Planning Commission

Regular Meeting Agenda

Frances Meaders Council Chambers
January 27, 2025 | 6:30 PM

SUBJECT: Landscape Plan, Aventure Aviation, 108 International Drive

SHEET TITLE:
LANDSCAPE PLAN

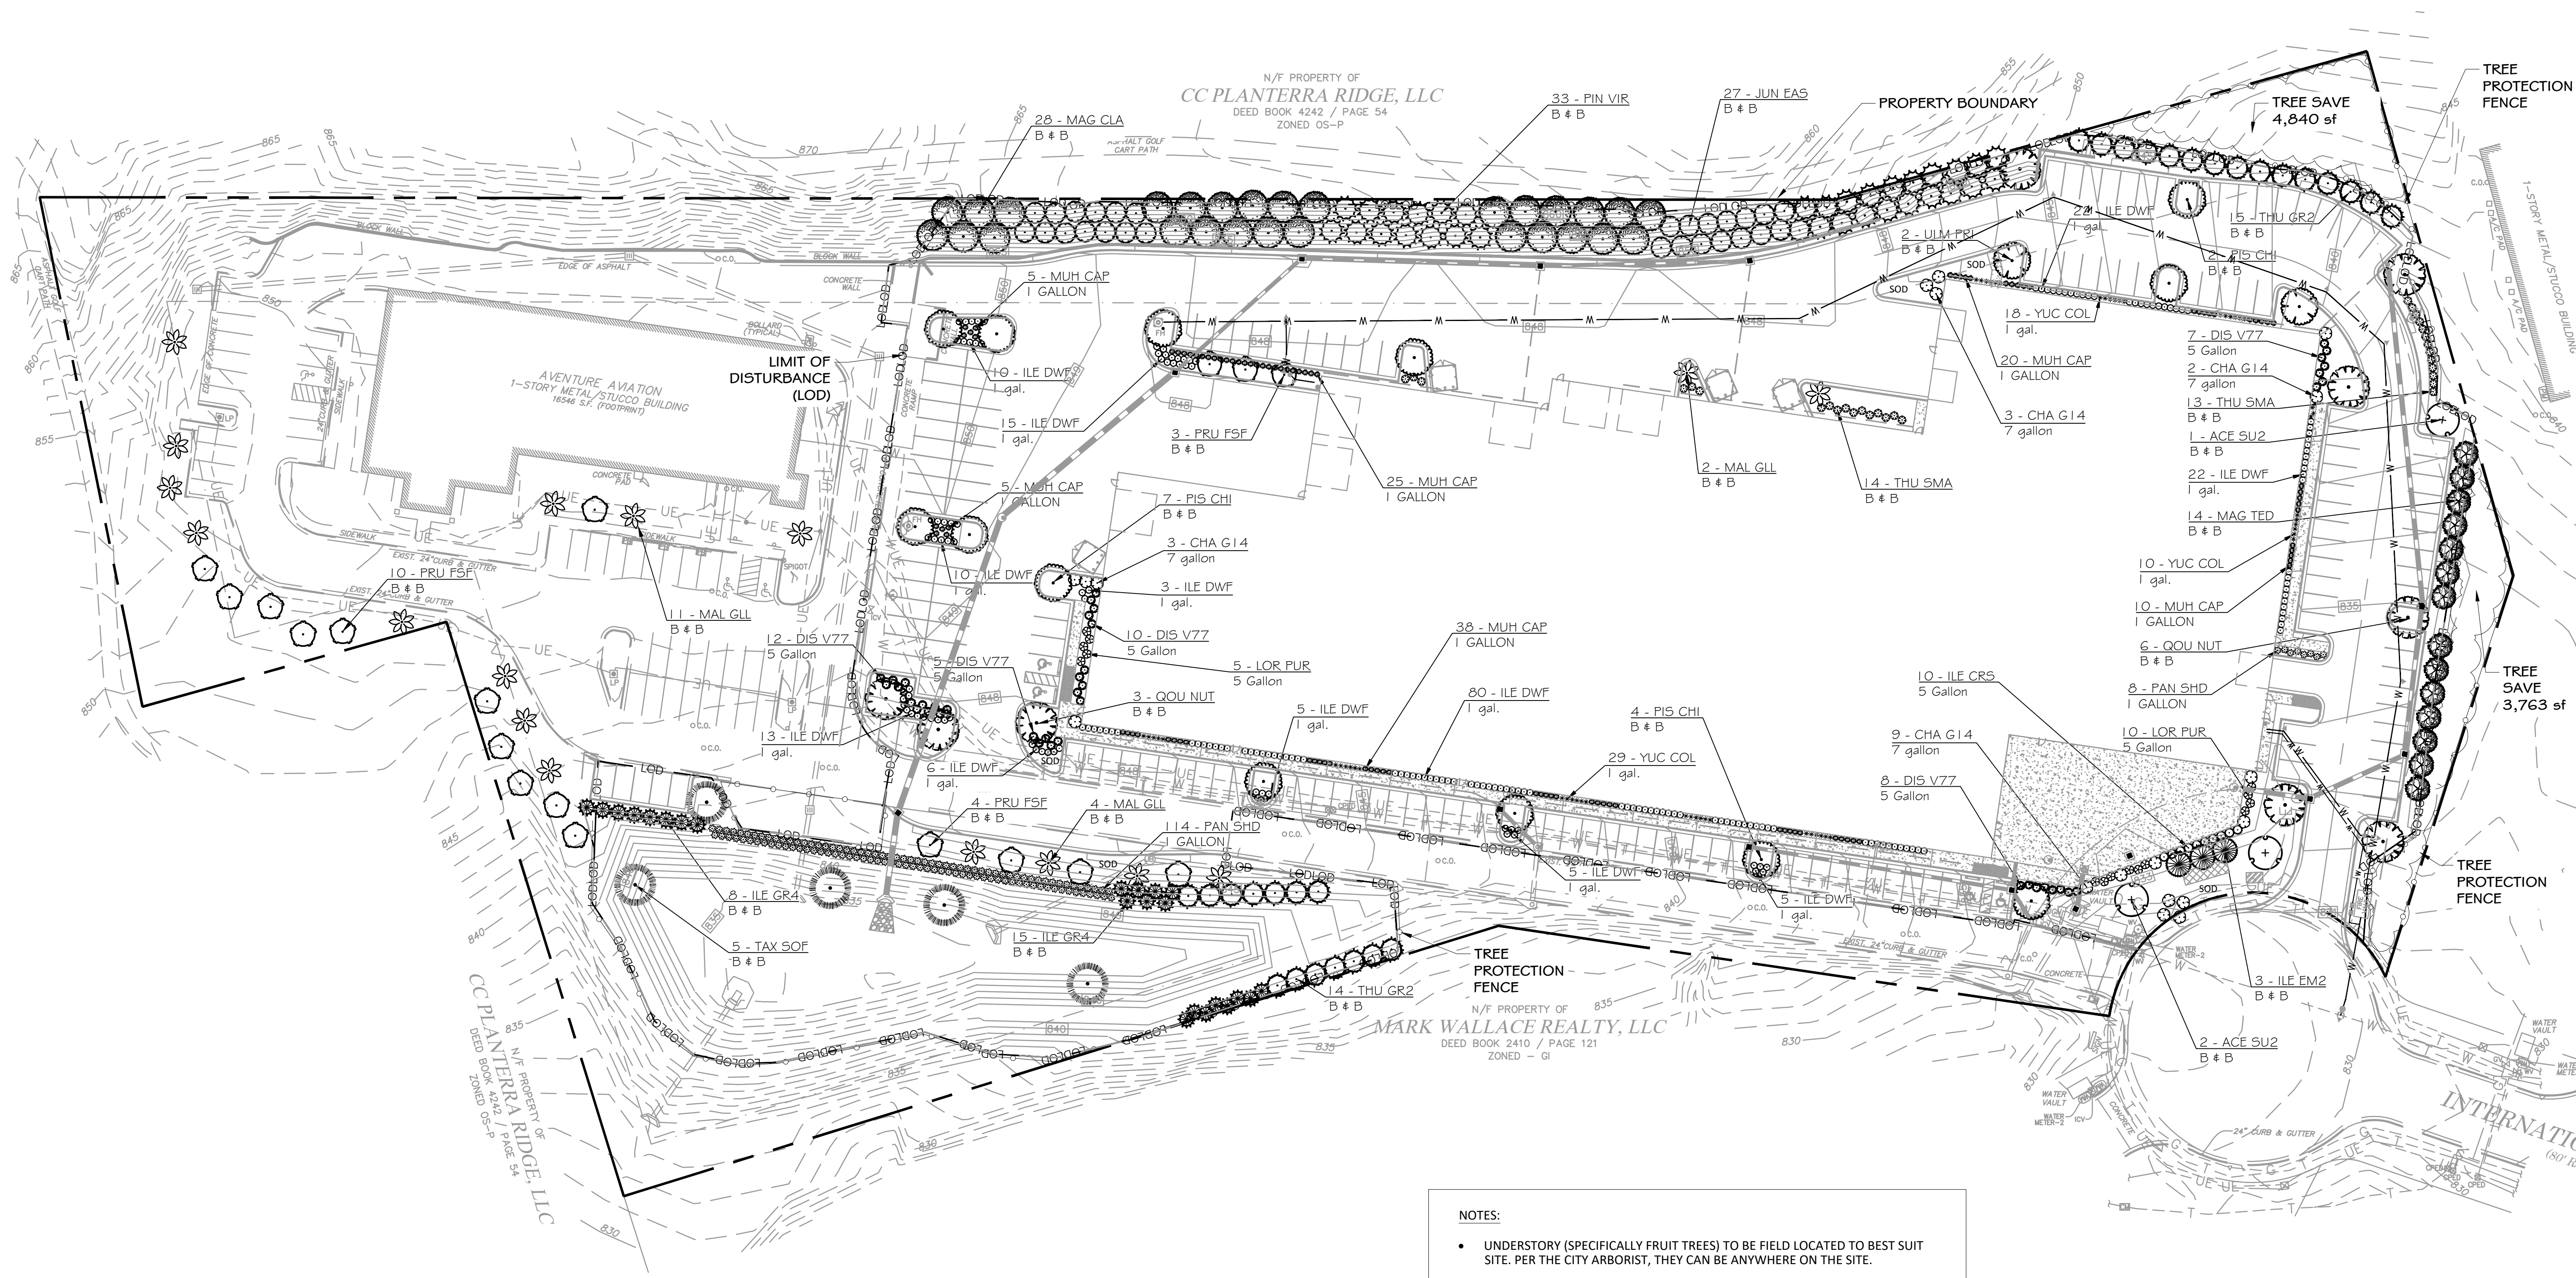
Based on the amount of new impervious surface area (179,032 SF), which includes new structures, drives, parking areas, and sidewalks, the landscape ordinance requires a minimum of 537 caliper inches of overstory trees and 358 inches of understory trees.

A tree save area of 8,603 SF has been identified. Per Section 1110(e) of the Land Development Ordinance (LDO), the Planning Commission may permit up to a 25% reduction in the total number of trees required. The tree credit calculation is as follows, (designated area / total site area) X 100: $(8603/418,612) \times 100 = 0.021$ or 2.1%. Based on the calculated tree credit, the new total for caliper inches required is 526 overstory inches and 350 understory inches.

The proposal is for 447 inches of canopy trees and 233 inches of understory trees. See table for calculations below:

Section 1114.5 of the LDO permits the tree fund compliance method after all the trees that can be reasonably planted on the site are provided. It is the opinion of staff that this requirement has been met.

Staff is of the opinion the landscape plan for Aventure Aviation, located at 108 International Drive, meets the requirements of the City ordinances and recommends approval.
